REPORT TO DESIGN COMMISSION City of Sacramento

PUBLIC HEARING
September 15, 2010

Subject: 3820 Broadway (P10-042) Located at the southeast corner of Broadway and Martin Luther King Jr, Boulevard, a request to develop a three story 56 unit residential with ground floor retail on 1.2+/- acres in the Broadway/Stockton and Oak Park Special Planning District (C-1-SPD) zone.

BROADWAY ENLARGED ELEVATION - CORNER PLAZA | OPTION B

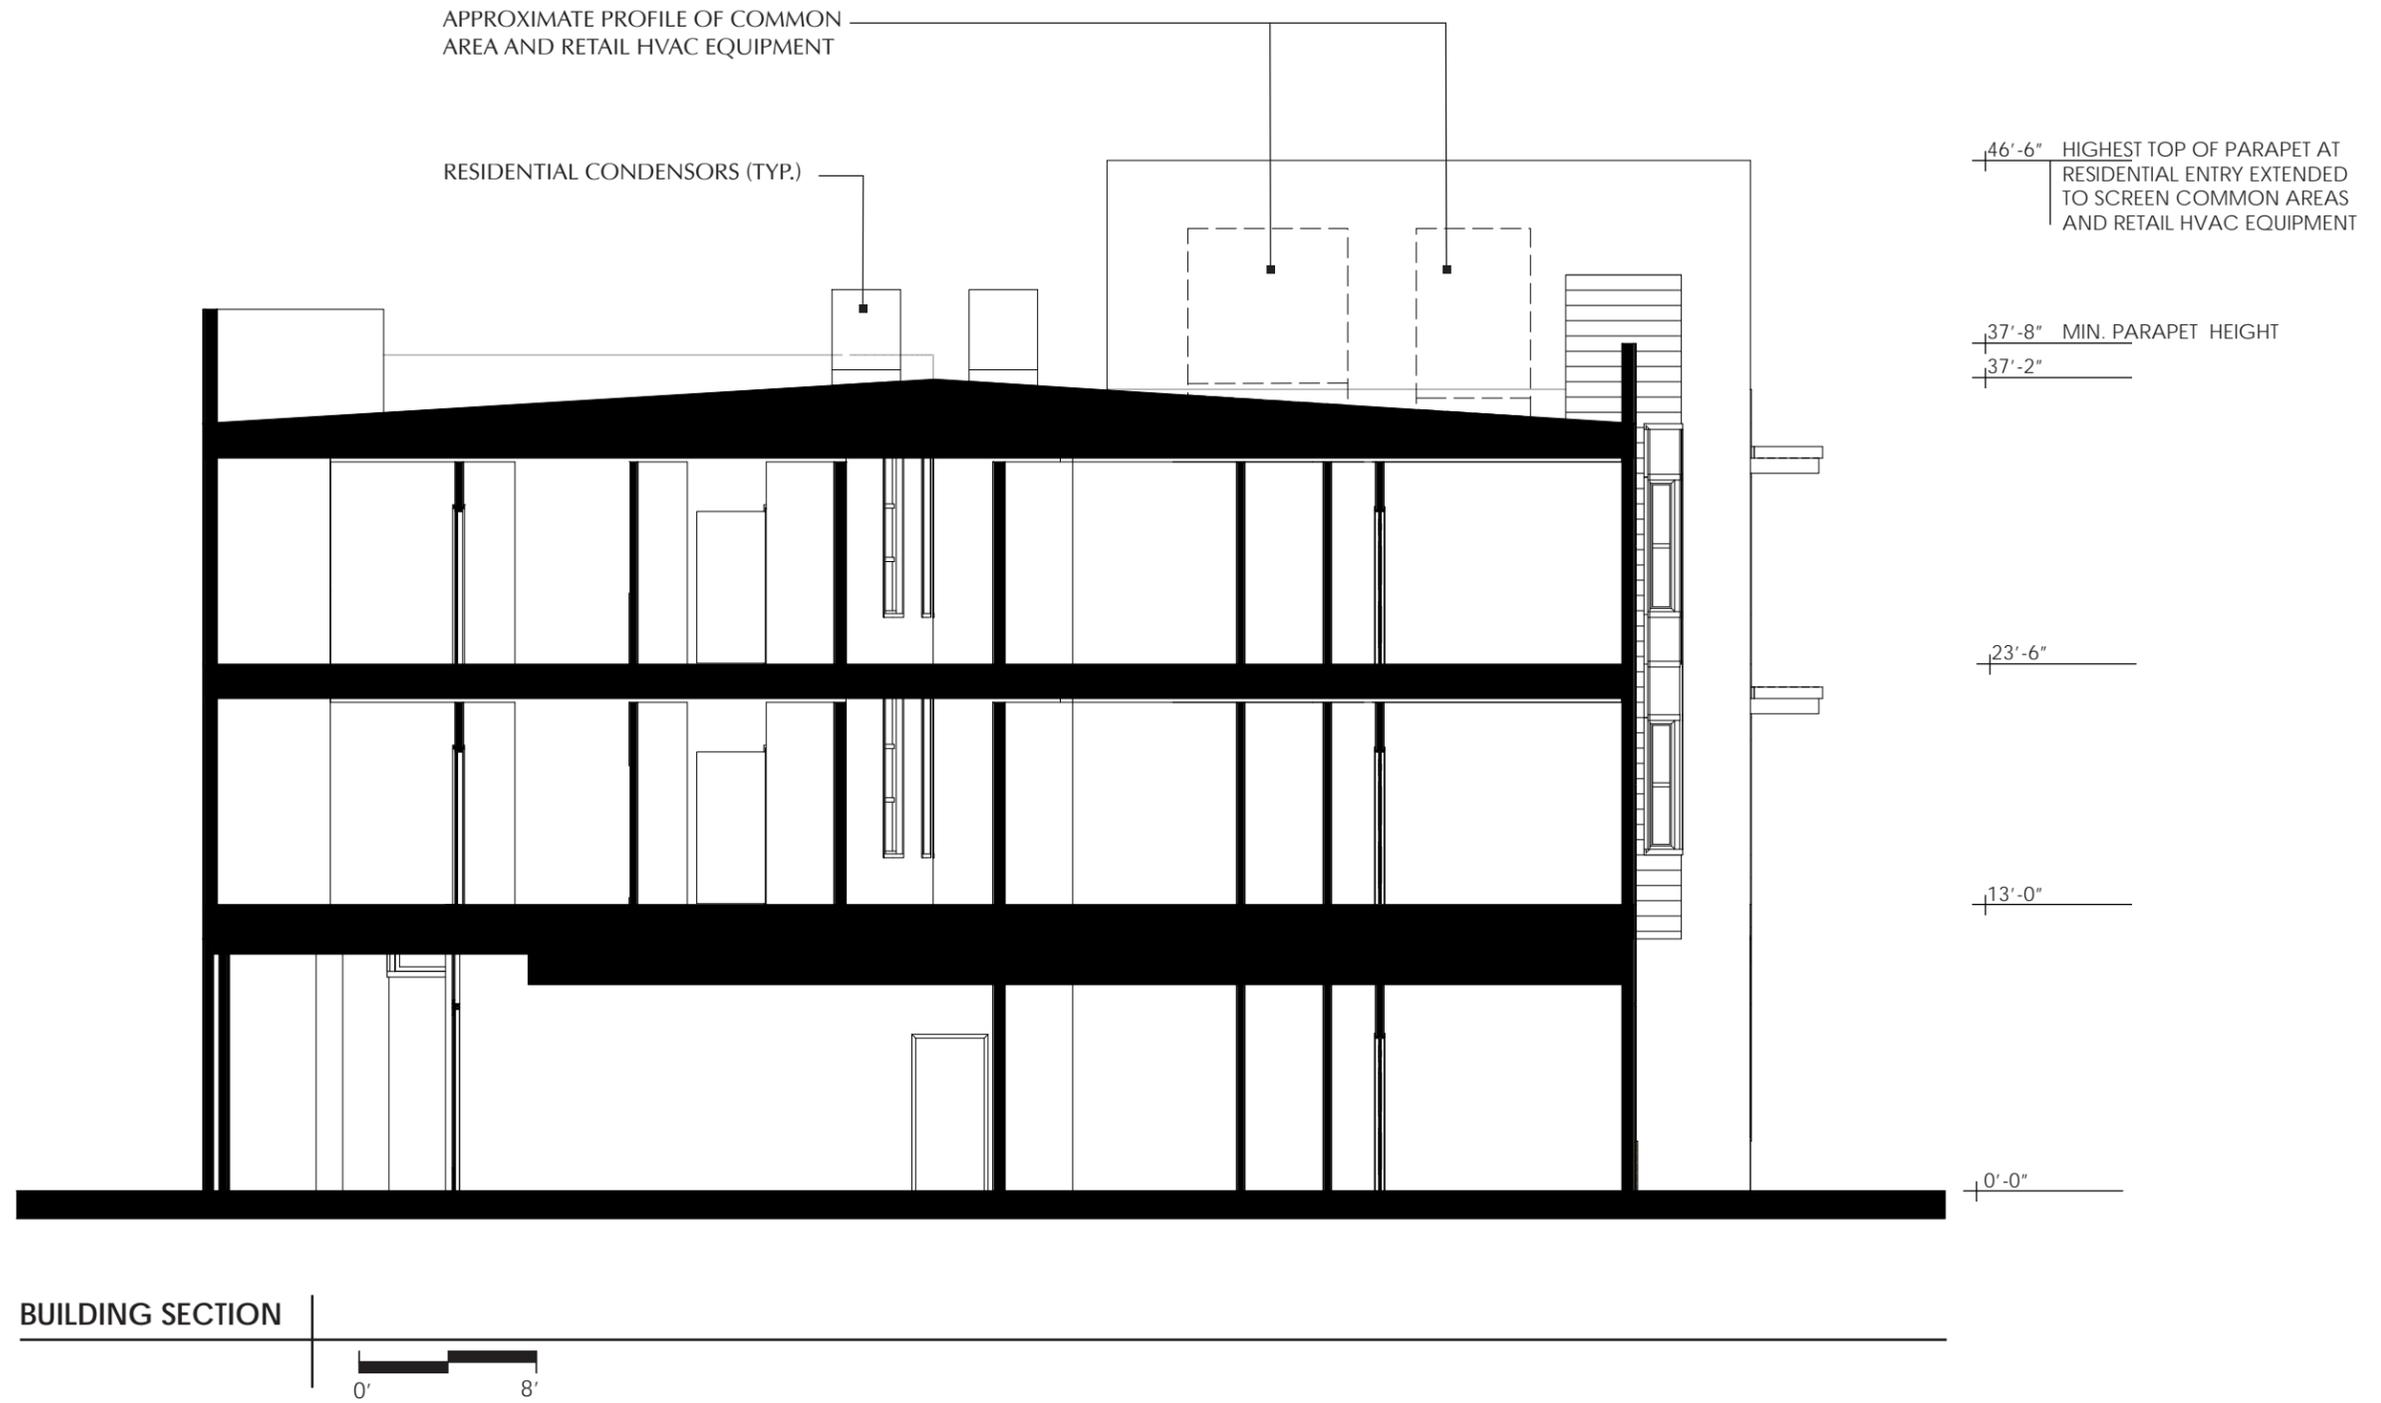
1. The corner element needs further refinement and integration into the design of the building. The recessed element appears dark and should be studied further to provide a more inviting and active atmosphere.

2. Study spacing of columns and possibly push the outside columns closer to the building to open space up. The third floor corner unit could benefit from the visual continuation of the columns up through and integrated into the plaster wall element. Possibly enhance the corner by changing the window sizes to an atypical size instead of the standard size used at the other elevations. The tall ceiling at corner might be an issue, look at curved walls at corner.

3. Suggest that applicant look at changing the brick height up to halfway between the 2nd and 3rd floors, this would allow a visual separation of the retail and residential spaces.

4. The Broadway elevation needs a better relationship between styles and elements at the corner as they seem disparate. The massing of the column bases appear over scaled and could use some further study and refinement.

10. Due to the fast turnaround time, the corner element issues have not been resolved. The corner issue includes the use of brick, location and integration of columns, changes to column bases and capitals, and locations and design of bollards. The applicant has provided two options for the column base design and staff recommends Option B which includes a lower round base. Applicant should provide revised corner element detail at the hearings.

- d. We believe the brick height on the corner is correct as shown in the 3rd submittal (that was presented to DRC for preliminary review). It coincides with defining the retail space clearly and coincides with the railing height for the second floor balconies thus providing a continuous horizontal line with the top of the brick that add to the strength of the corner mass.

ROOF PLAN

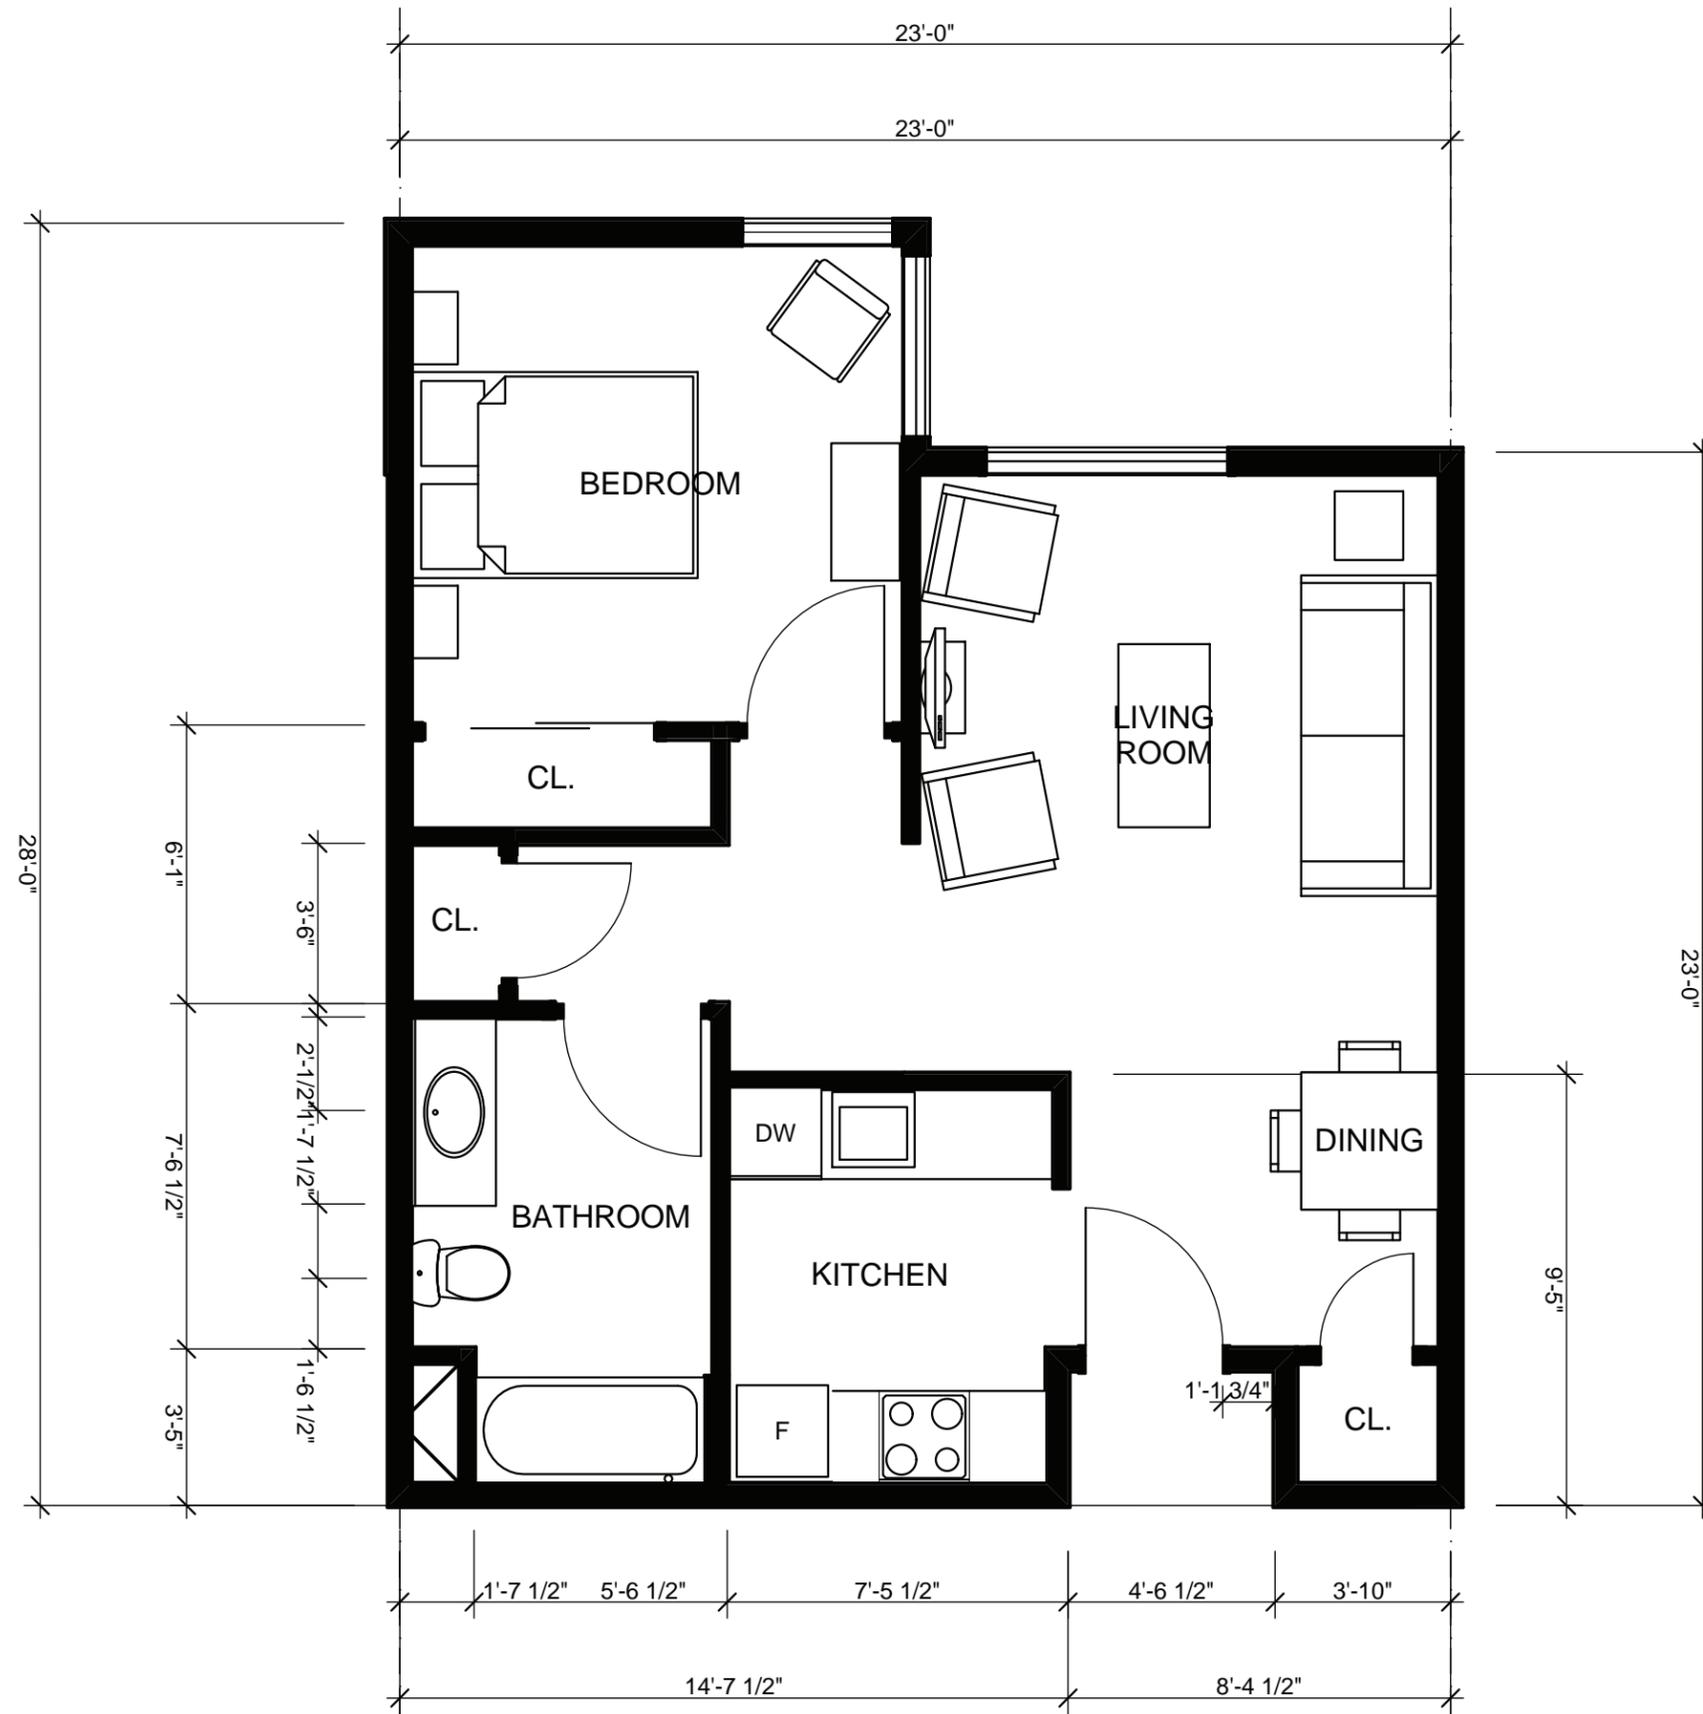
- 13. The applicant provided staff with a roof plan and cross-section regarding the mechanical system locations and heights. Staff is supportive of the HVAC locations as the small units will have minimal height and hidden behind the parapet, and the larger common space units will be located behind the entry parapet.

16. **Staff recommends that a roof plan, cross-sections, and details of the mechanical parapet walls and the associated mechanical equipment be provided to the Design Commission at the review and comment hearing.** Mechanical systems should be located behind the parapet wall and not visible from any street or pedestrian views.

25. The common residential area HVAC system shall be incorporated within the main entry parapet and the residential unit HVAC systems shall be located behind the parapet wall, so as not to be visible from any street views. **Final roof plan with mechanical equipment locations, a section through the HVAC unit and building, and cut sheets shall be reviewed and approved by Design Review staff prior to Building Permit submittal.**
